RTA 2 (O.N. 1290301)

Vessel Inspection Report

Prepared for: New Orleans RTA • New Orleans, LA

Ref: 19100-002-986-0 Rev. - December 10, 2019

Figure 1: Wet Deck Seam

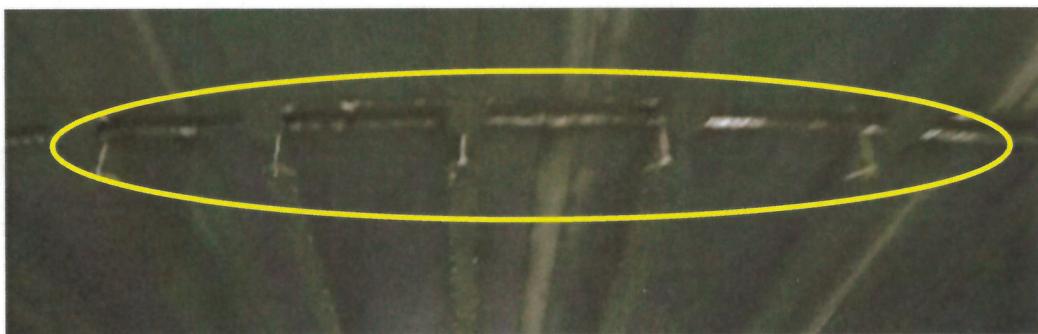
1. The "wet deck" is extruded plank rather than corrugated sheet as shown in, Ref. [1] Midship Section. The transverse seams appear to be continuously welded, Figure 1, protecting the wet deck void from water ingress.

Figure 5: Stiffeners Adjacent to Keel

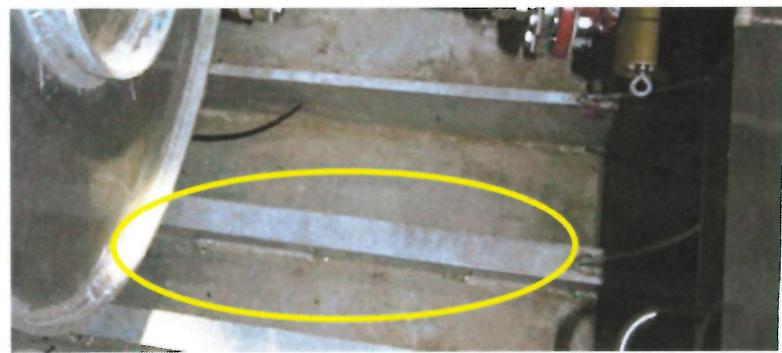
5. The first stiffeners adjacent to the keel bar, Figure 5, are to be welded DC per the Welding Arrangement, Ref. [3].

Figure 6: Pillar Foundation

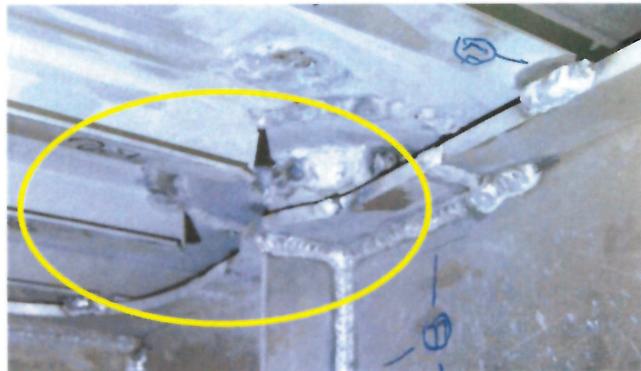
6. The deck planking stiffeners have been cut short and left unsupported in way of the pillar foundations, Figure 6.

Figure 14: Starboard Tanks Compartment Bilge

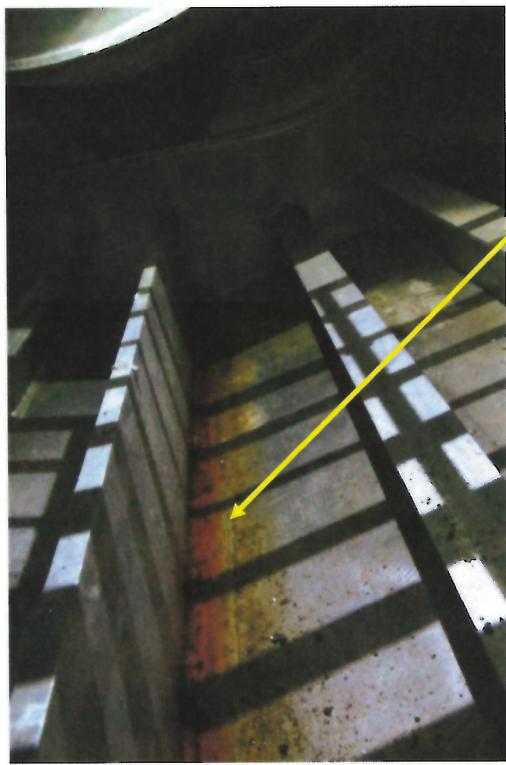
Compartment had diesel in the bilge and significant diesel fumes, so it was not safe for entry and was not inspected, Figure 14.

Figure 15: Deck Edge Bracket

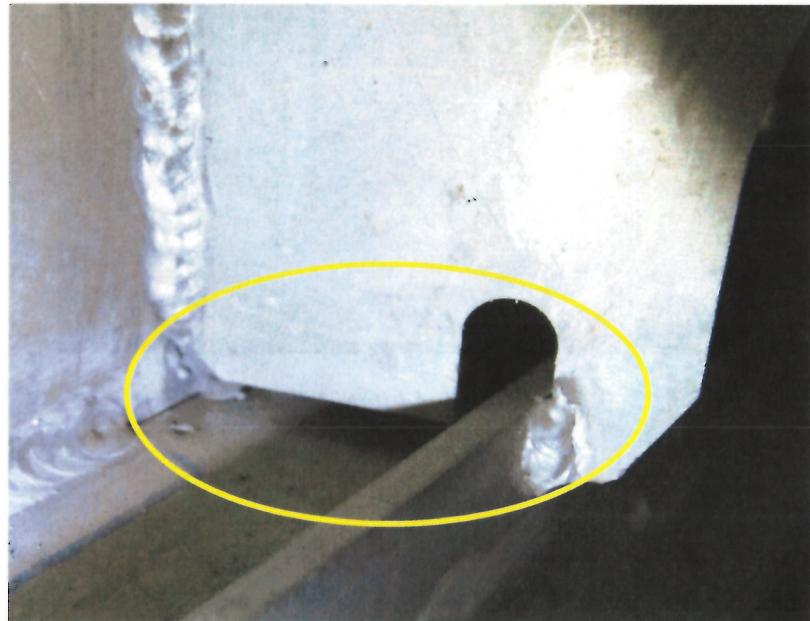
1. Deck edge bracket end connection not welded, Figure 15.

Figure 20: Wheelchair Ramp Requirements

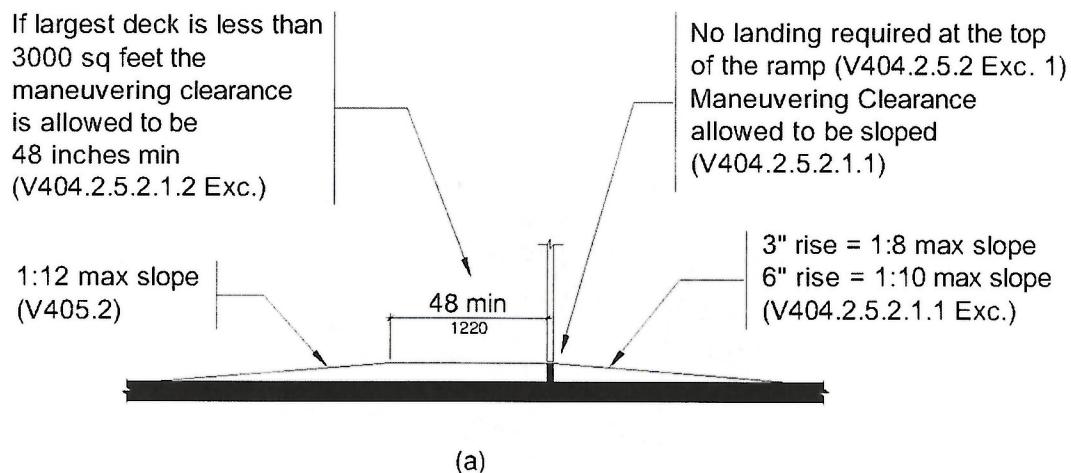
1. Wheelchair ramp not in compliance with ADA Chapter V4, Ref. [6]. Ramp rise shown in Figure 18 and ramp run-length shown in Figure 19.

Recommended Resolution: Ramp to be redesigned to meet ADA requirements.

Figure 21: Wheelchair Hold Down

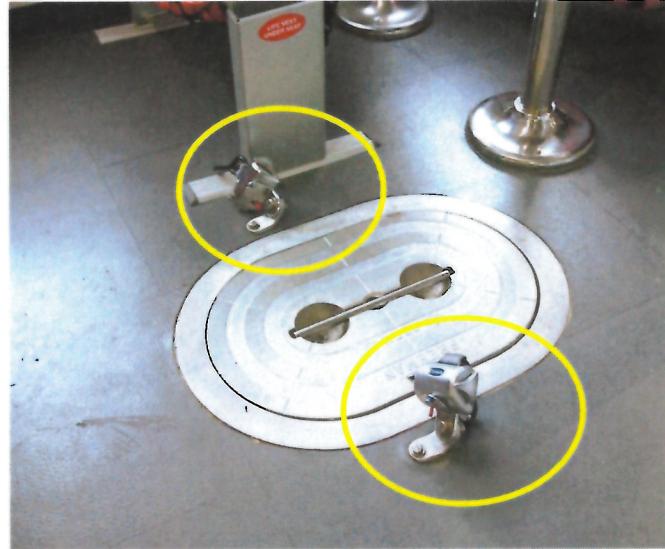
2. ADA wheelchair hold down presents tripping hazard as currently installed.

Recommended Resolution: Wheelchair hold-down slots to prevent tripping hazard of unmarked wheelchair hold-downs.

Figure 23: Weathertight Door

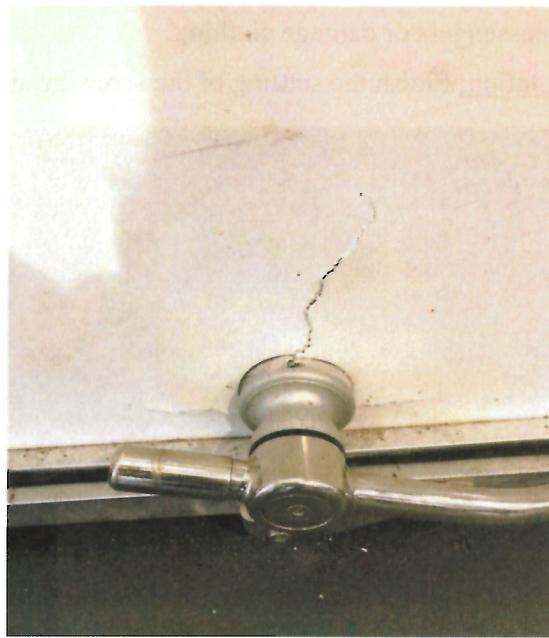
3. Weathertight door on port side of passenger compartment is damaged. Several dogs are non-functioning and have caused cracks to propagate.

Recommended Resolution: Replace door.

Figure 26: Damaged Exit Sign in Main Cabin

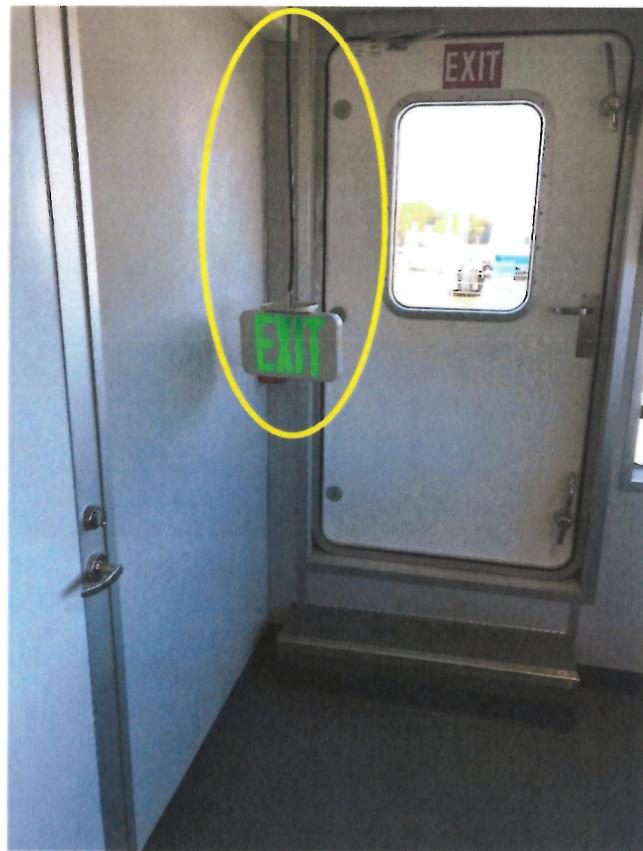
Exit sign mounted to overhead has broken and come loose. Adjacent to forward access door of main passenger compartment on Main Deck.

Recommended Resolution: Repair or replace all exit signs with a more durable fixture.

Figure 27: Anchor Locking Pin

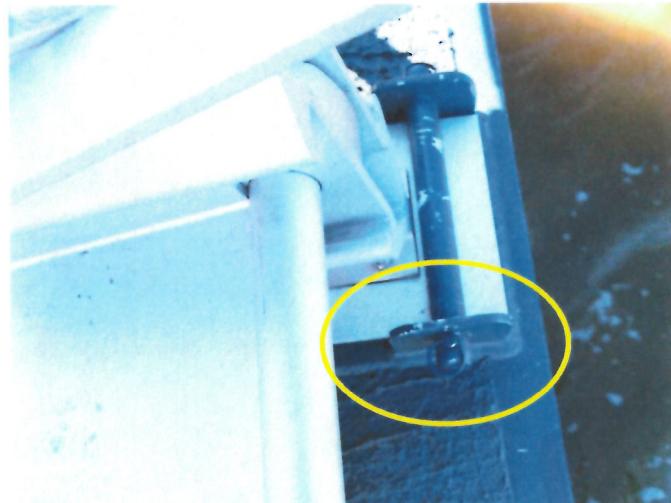
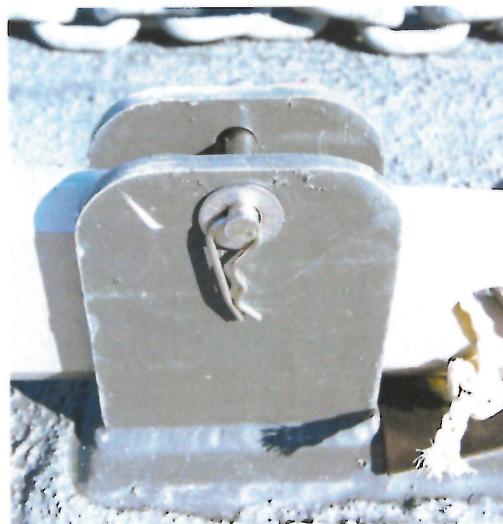
Anchor deployment will be difficult to deploy in an emergency. Pull pins shown in Figure 27 and Figure 28.

Recommended Resolution: Redesign with different pull pins used for fast and safer operation.

Figure 33: Deck Bolting Head Clearance

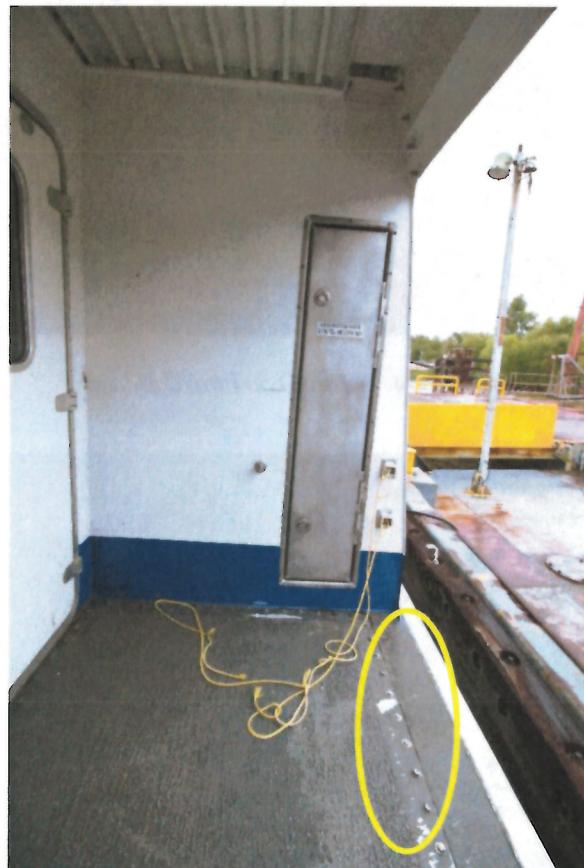
Bolted Equipment Removal Panel (BERP) is bolted in; port side is leaking; bolts on BERP are not flush. This creates a passenger/personnel hazard.

Recommended Resolution: Modify bolting so that the bolt heads do not extend up beyond the level of the deck plate or BERP plate. Condition is noted on exterior of the Upper Deck in passenger area, also.

Figure 39: Fuel Tank Connections

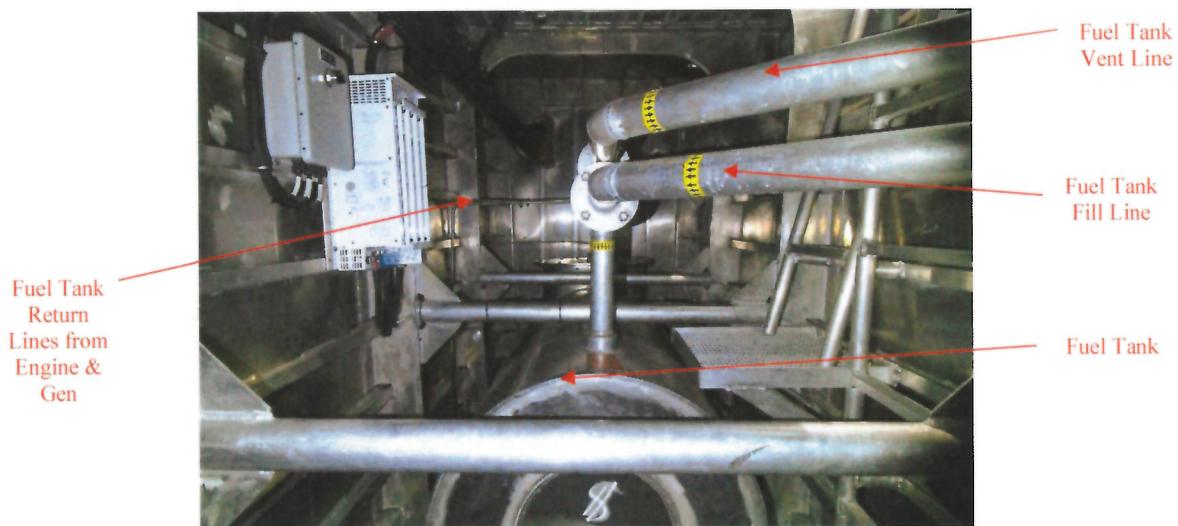
Within compartments R103 port and starboard, operating personnel cannot manually confirm how much fuel is on board in the fuel tanks. Tank levels cannot be manually determined with the present configuration of tank hardware. The inability to know much fuel is in the fuel tanks prohibited RTA personnel from running the diesel machinery and EBDG personnel from being able to observe the main engines and generators in operation. Therefore, EBDG was unable to verify the main engines and generator engines in operation during the inspection. Sounding system needs to be modified or repaired.

Recommended Resolution: Possible solution is to install USCG approved sight glass on forward end of fuel tank.

Figure 40: Black Water Tank Vent Location

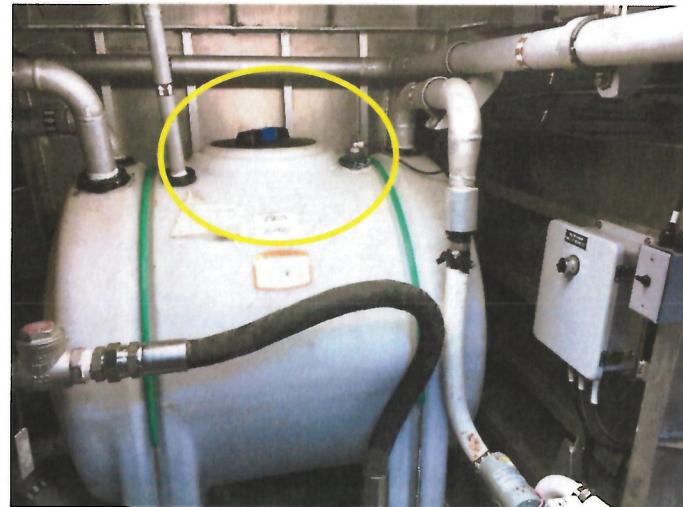
Tank is located in a below main deck compartment R101 starboard. It is unclear whether the cap is properly sealed to avoid venting into the space.

Recommended Resolution: Verify tank cap is properly sealed and ensure proper venting outside the tank compartment.

Figure 42: 24VDC Emergency Lighting Circuit Still Energized after Trip

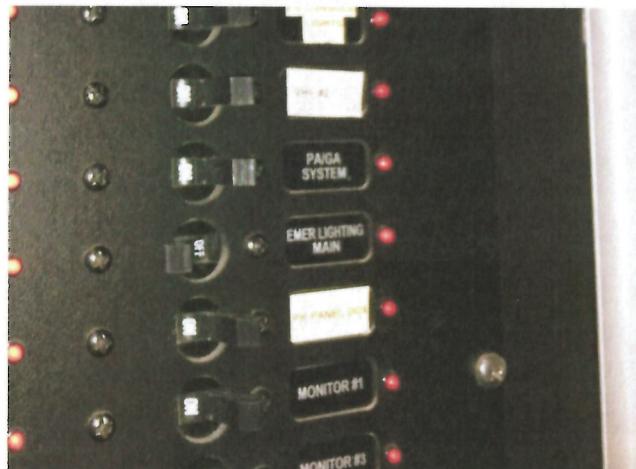
Emergency lighting in the main deck passenger area trips offline. When attempting to reset the DC supply in Panel DC#3, the panels ammeter actually drops from approximately 8 amps into the negative region, then the supply breaker trips after a few seconds. Once the breaker trips the indicator lamp remains lit, indicating the circuit is still energized. EBDG suspects the emergency lighting inverter is back feeding the circuit. Also, the emergency lighting drawing calls for a 25 amp breaker in Panel DC#3 to feed the emergency lighting. Breaker sizes are not identified in the Newmar panels, but an undersized or faulty breaker is suspected. Note this issue went away after the vessel was connected to shore power for several hours, indicating that a low battery charge was a factor.

Recommended Resolution: Verify correct breaker is installed. Research back feed issue and correct as needed.

Figure 43: Partially Removed Number Labels in Panel P23

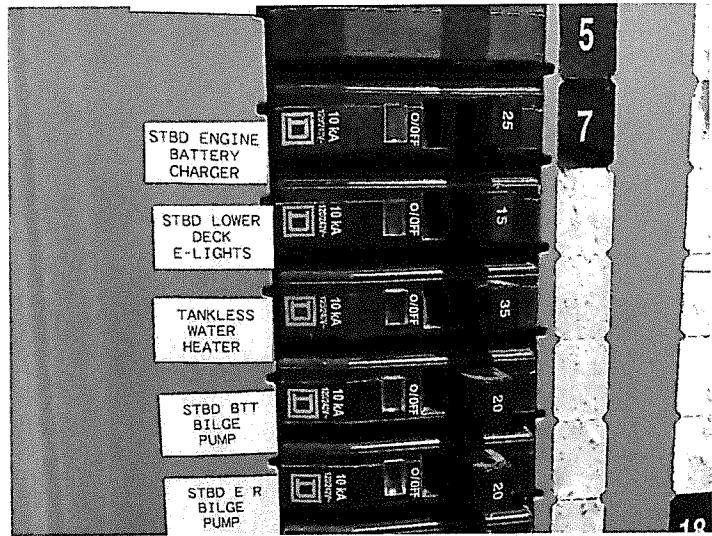
Panel P23 in the crew office has circuit number labels partially removed. The remaining panels, P21, P22, and P24 have no circuit number identifying labels.

Recommended Resolution: Rework panel circuit breaker labels so that each breaker has a unique circuit number.
